Technical Service Bulletin

TSB0706: 2006 King forks.

December 9, 2005

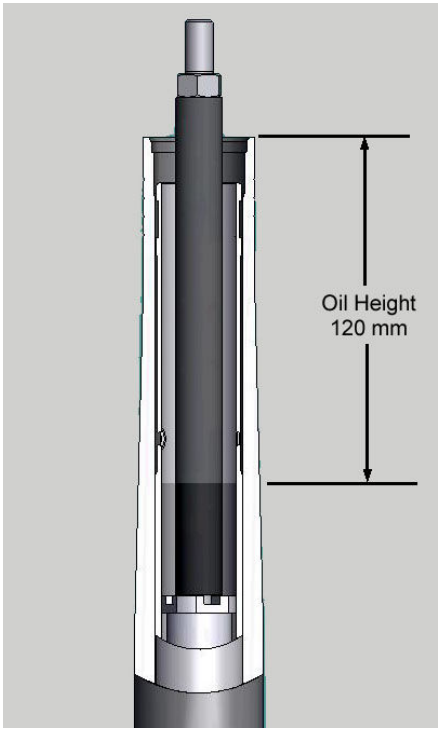
The fork oil in the 2006 King forks should be set at 120mm from the top edge of the outer tube with the forks collapsed down, spring removed, and damper rod down. Some units shipped early had too much fork oil.

CAUTION
Too much fork oil can cause damage to fork tubes and components.

When filling a dry fork leg, 120mm works out to be 107cc.
